METFORD MEDICAL

ARCHITECTURAL DRAWING SCHEDULE

ISSUE FOR DA

REVISION 2 UPDATES (01/12/23)

SHADOW DIAGRAM JUN-21-3PM

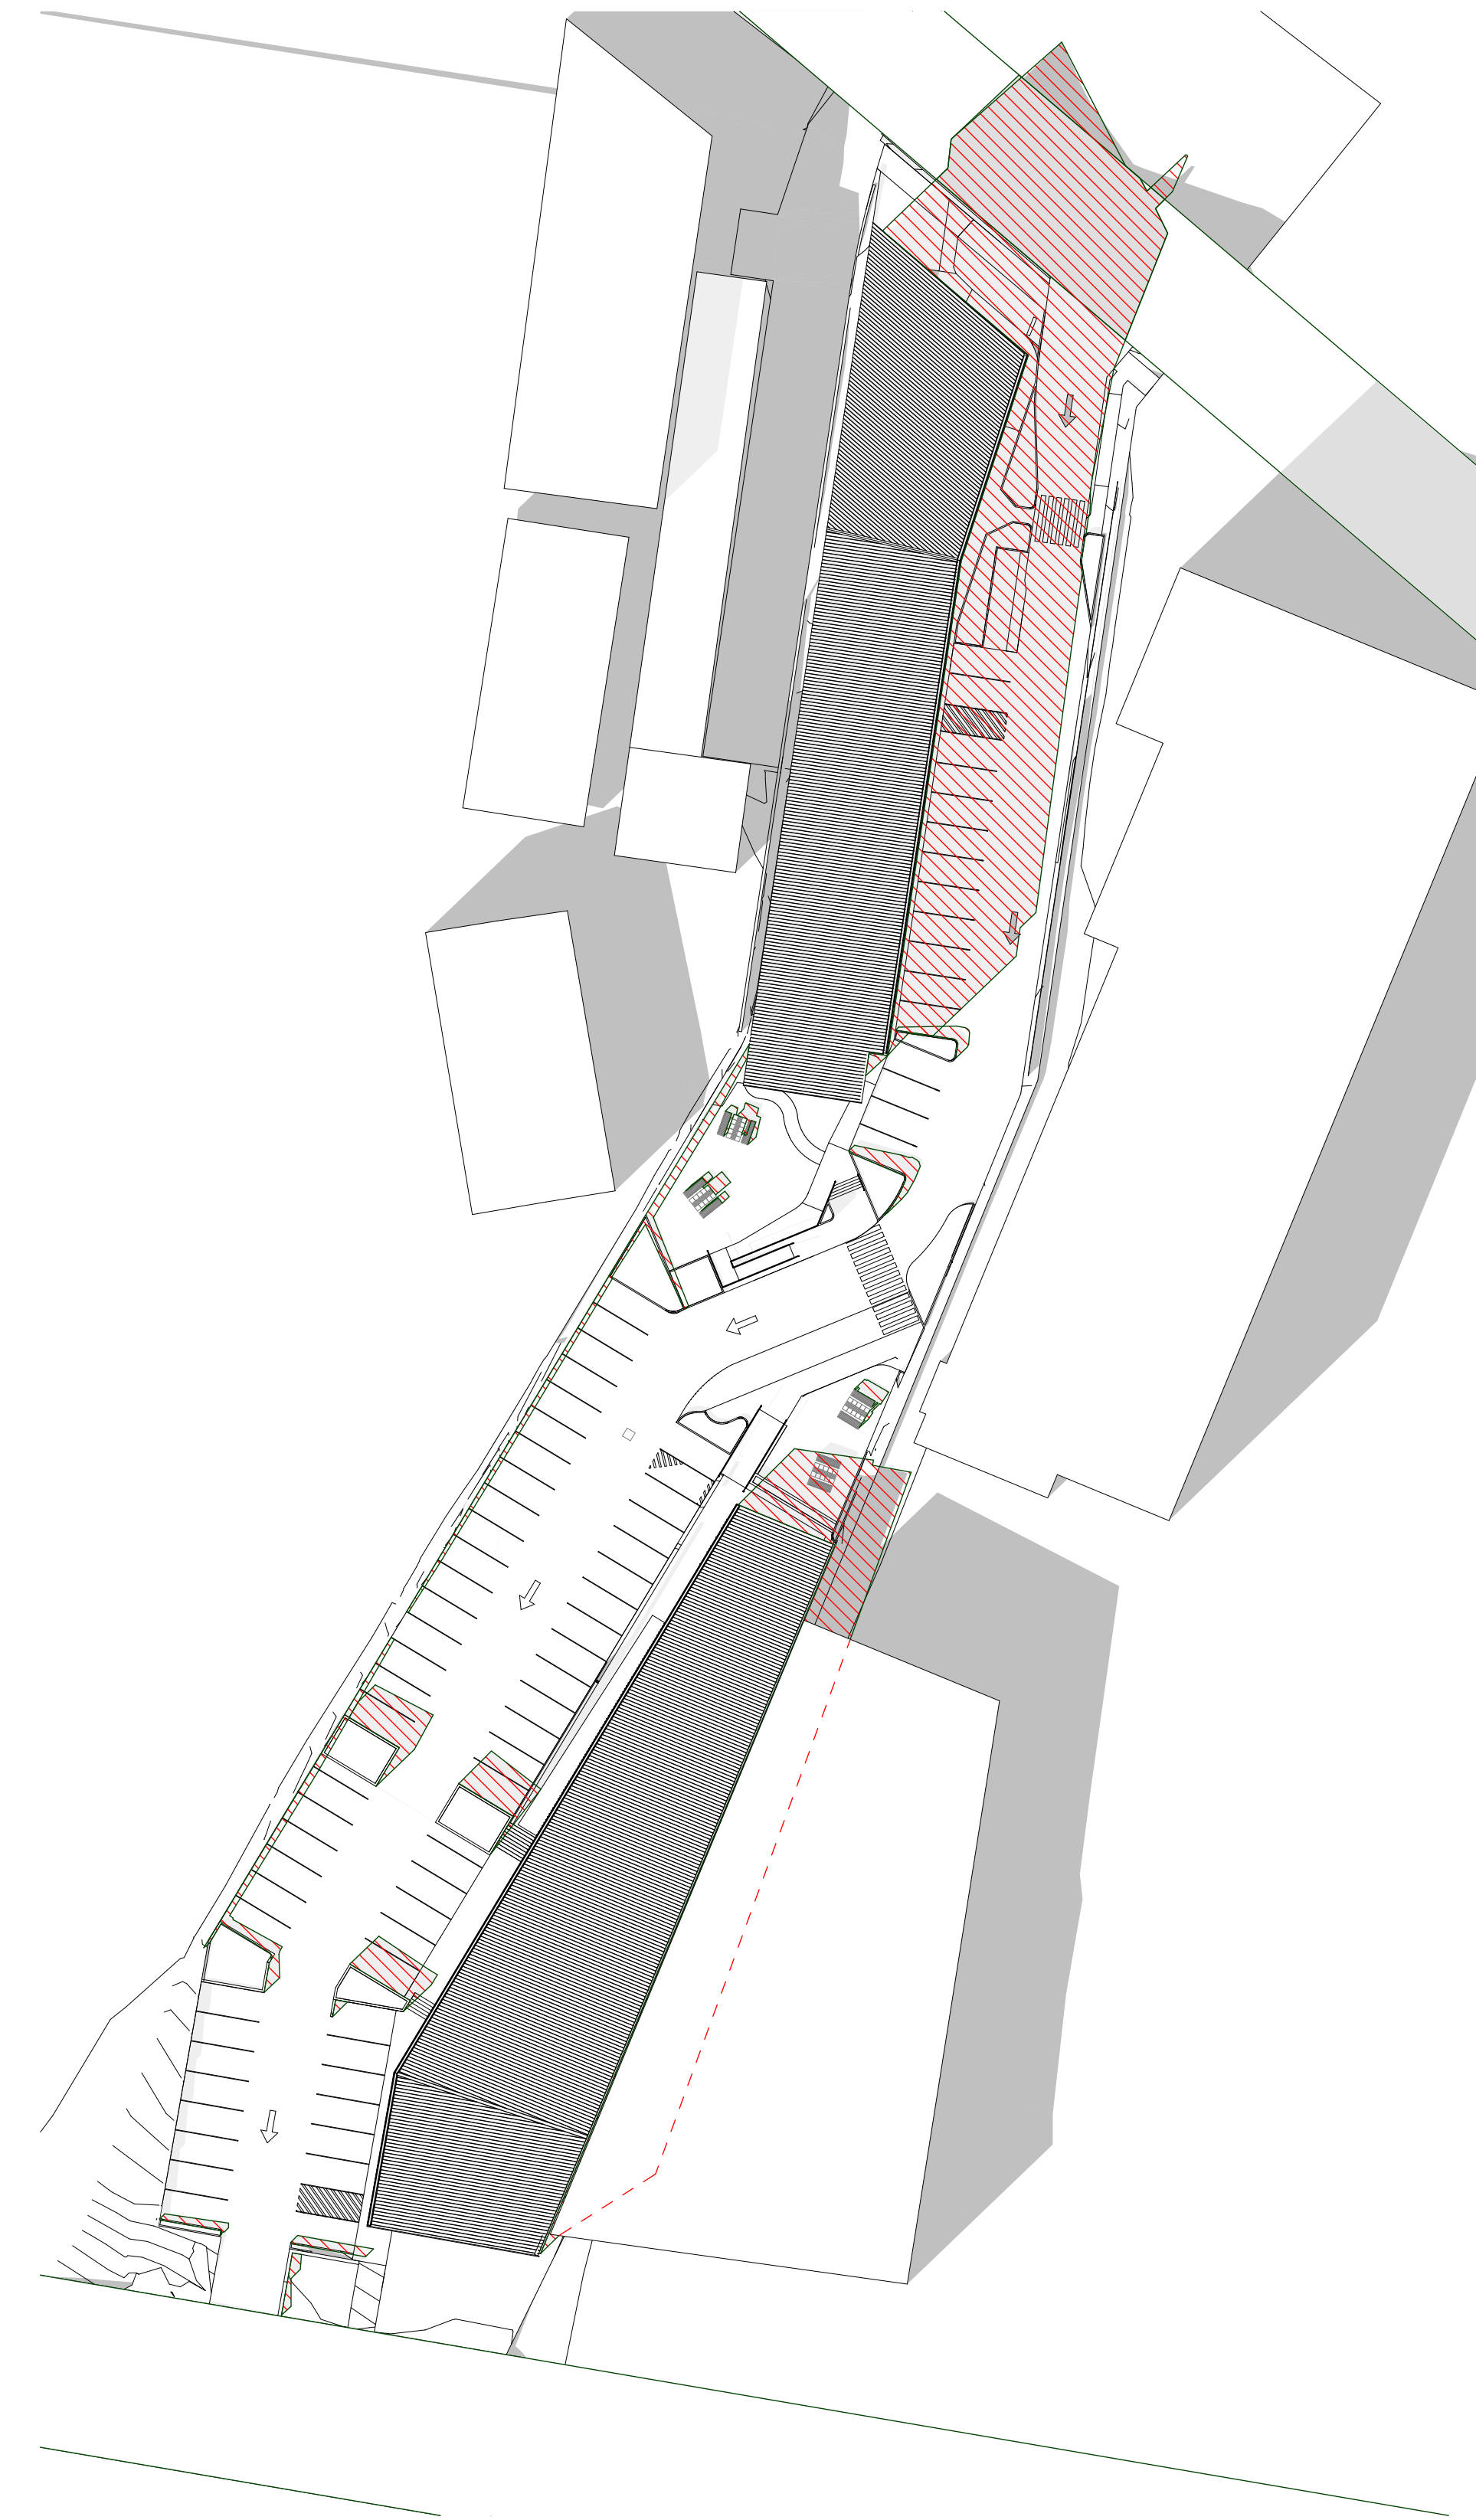
REVISION 2 UPDATES (01/12/23)
- BUILDING A STREET FRONTAGE BULK REDUCED
